Town of Paradise Valley

Meeting Notice and Agenda Planning Commission

A. [17-390](#) **Consideration of Hillside Code Updates (Article XXII of the Town Zoning Ordinance)**

File #: 17-390

FIGURE 3 — PRIMARY RIDGE LINE DESIGNATION

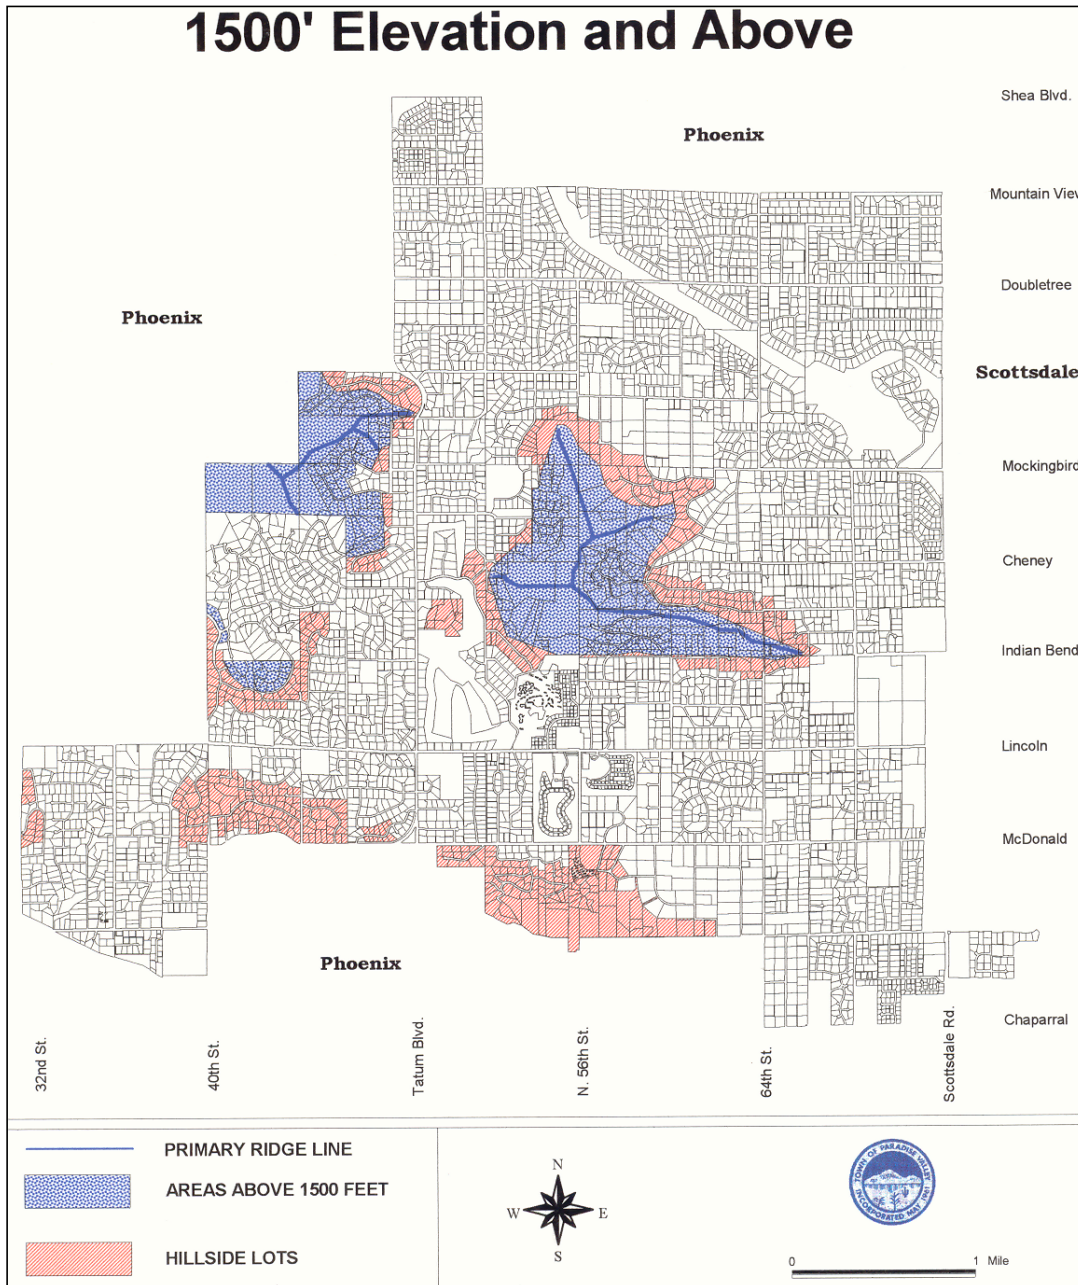
Comment [GB1]: Figure 3 Moved after Definition Section on Page 9

FIGURE 4 – RIDGE LINE TWENTY DEGREE DELINEATION

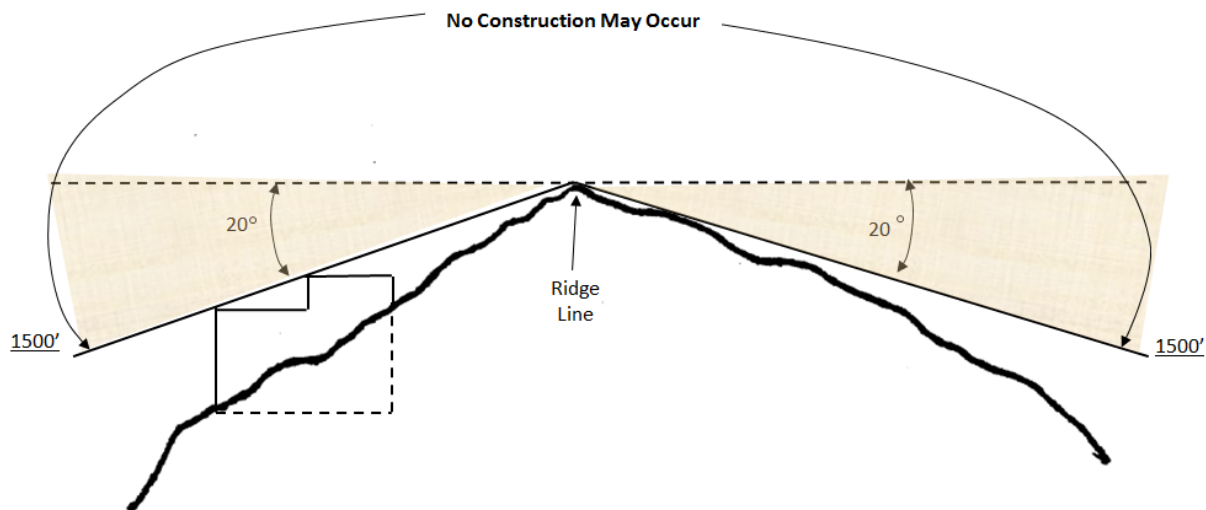
- Safety Section. The Commission identified safety triggers such as unique topography, difficult access to a site, unstable rock formations, and steep slopes. The Commission also identified limiting this section to three safety plans of site construction, geological reports & seismic refraction surveys, and blasting.
- Cantilevers. Add width and height dimensions to the new illustration and update the definition of cantilever to address allowable overhangs.
- Ridgeline Figure - Figure 4. Update the graphic to clarify the “no construction” area.

FIGURE 7 - HEIGHT FOR A CANTILEVERED ELEMENT

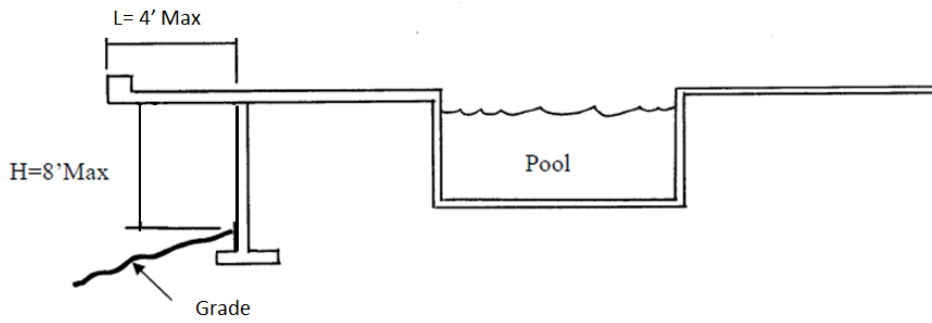
Comment [GB6]: New figures to be added to the code to illustrate these scenarios.

Comment [GB7]: Remove support from illustration and change horizontal to 4' max on Figure 7.

FIGURE 8 – TERRACED VERTICAL RETAINING WALLS

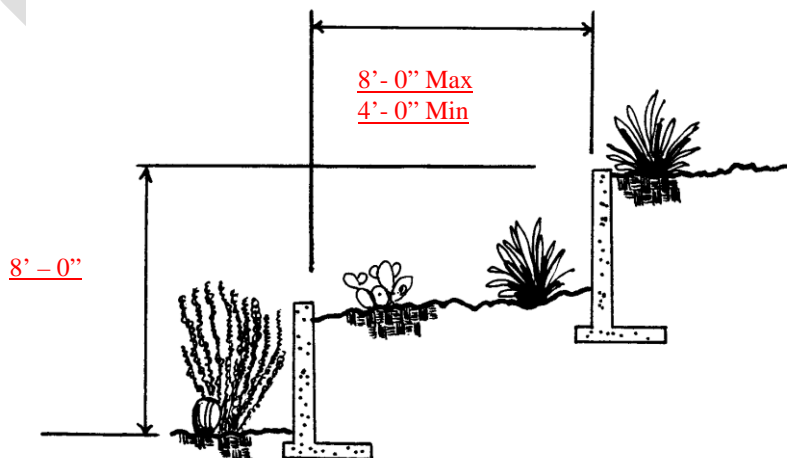
Comment [GB10]: Relocate Figure 8 below the text of 2207.VI.1.e.

FIGURE 7 - HEIGHT FOR A CANTILEVERED ELEMENT

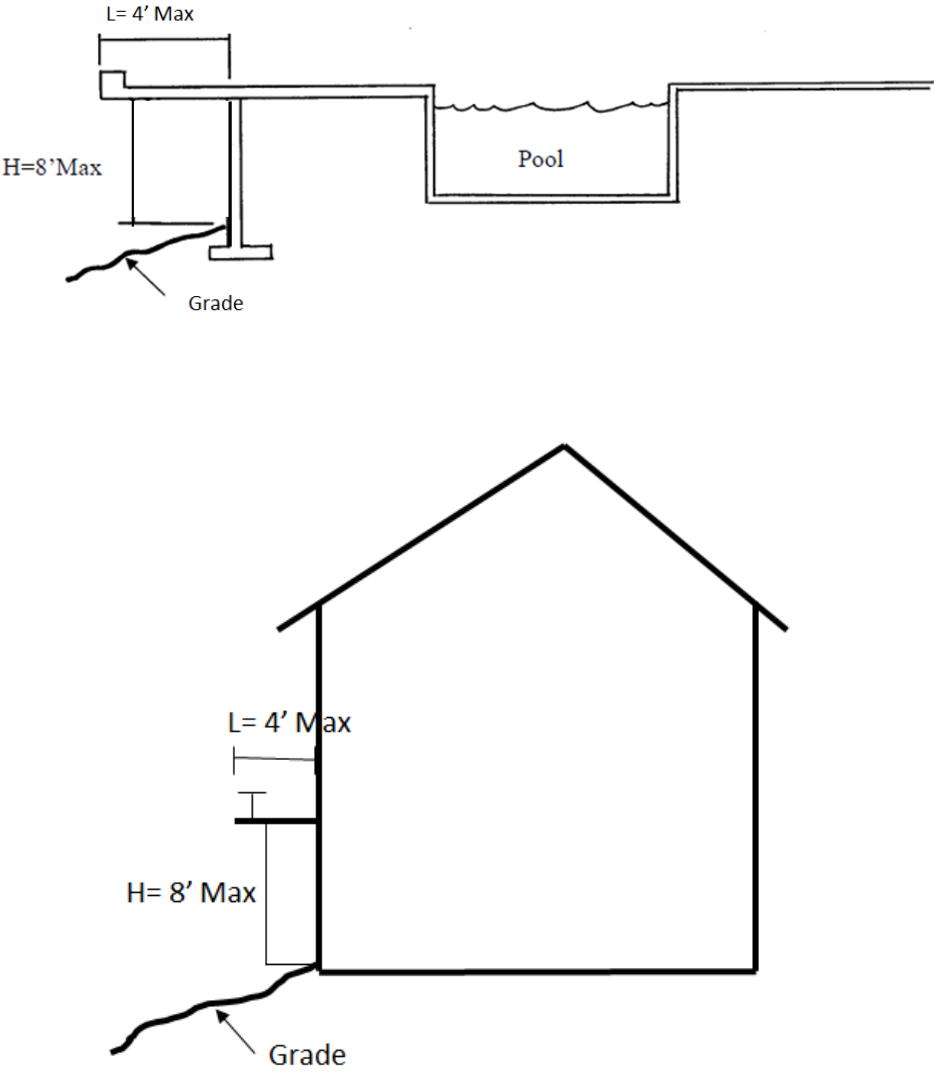
Comment [GB3]: New figures to be added to the code to illustrate these scenarios.
